DOMINION NUCLEAR CONNECTICUT, INC.
MILLSTONE POWER STATION UNIT 3
SUPPLEMENT TO A REQUEST FOR BRAZED JOINT STRUCTURAL INTEGRITY
ASSESSMENT METHODOLOGY, REQUEST IR-2-38, (TAC NO. MC8893)

**SUPPLEMENT TO A REQUEST FOR BRAZED JOINT STRUCTURAL
INTEGRITY ASSESSMENT METHODOLOGY, REQUEST IR-2-38,
(TAC NO. MC8893)**

FIGURE 1: TENSILE TEST SPECIMEN SCHEMATIC

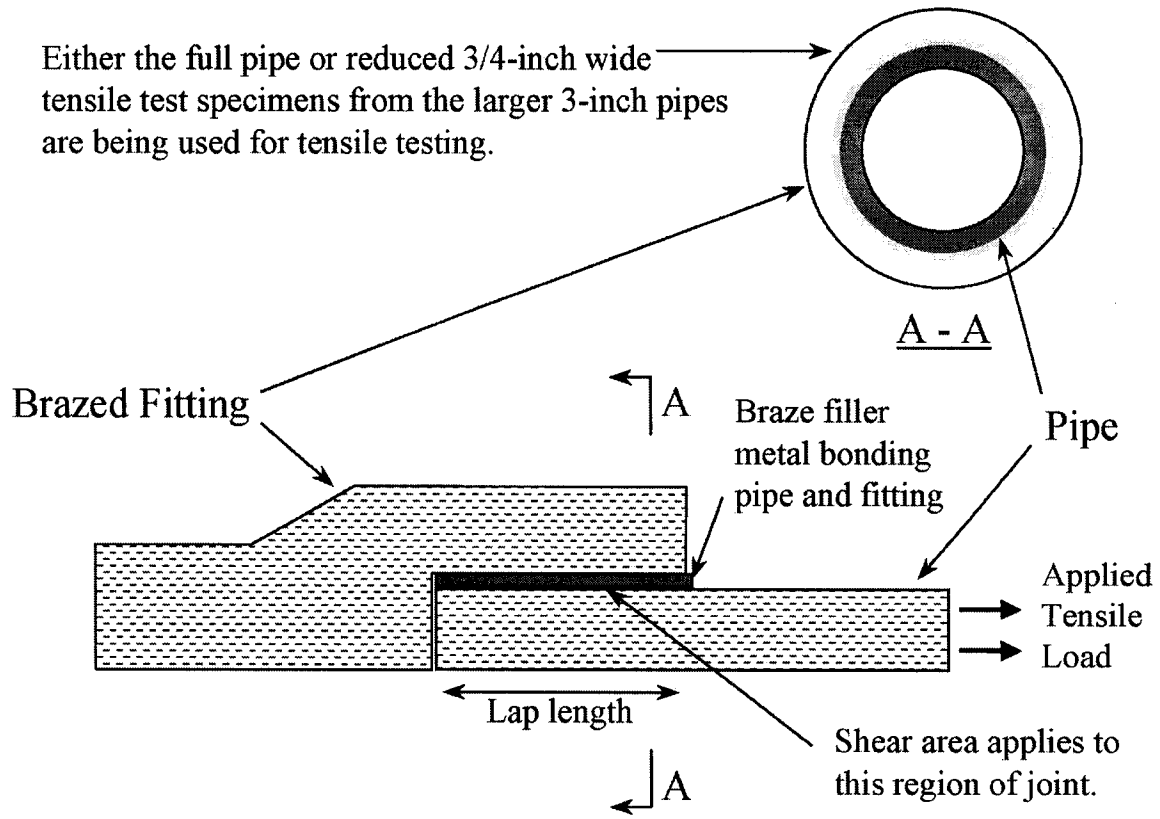
strength of the weaker of the two base metals joined. Figure 1 shows a simple schematic of a tensile test specimen. The tensile test specimen loads the braze bond in shear. The shear stress data in Table 1 was calculated by dividing the ultimate load by the theoretical shear area of each braze joint instead of the cross-sectional area of the pipe. Where failure occurred in the base metal (as was the case in all but two of the reported tests) the ultimate shear strength of the brazed joint was not measured but must be greater than the reported values.
